## 2.12 Station Electrical Systems

The information in this section of the reference ABWR DCD, including all subsections, figures and tables, is incorporated by reference with the following departures.

STD DEP T1 2.12-1 (Tables 2.12.1, 2.12.12, 2.12.14 and 2.12.15)

STD DEP T1 2.12-2 (Figure 2.12.15)

Figure 2.12.15 Instrument and Control Power Supply

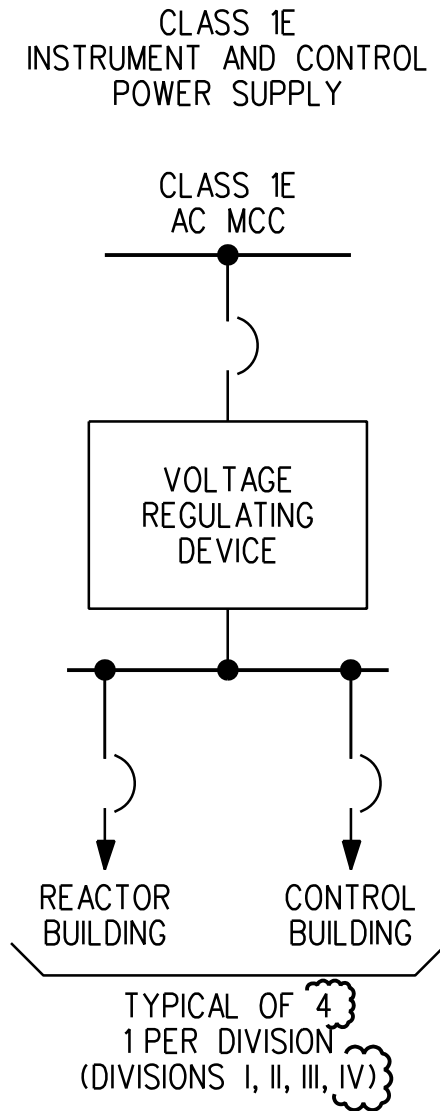
STD DEP T1 2.12-2

*The Class 1E Instrument and Control Power Supply consists of ~~three~~ four divisions (Division I, II, ~~and III, and IV~~) of interruptible power supplies with their respective distribution panels. Each Class 1E power supply provides interruptible, regulated AC power to Class 1E circuits which do not require continuity of power during a loss of preferred power (LOPP).*
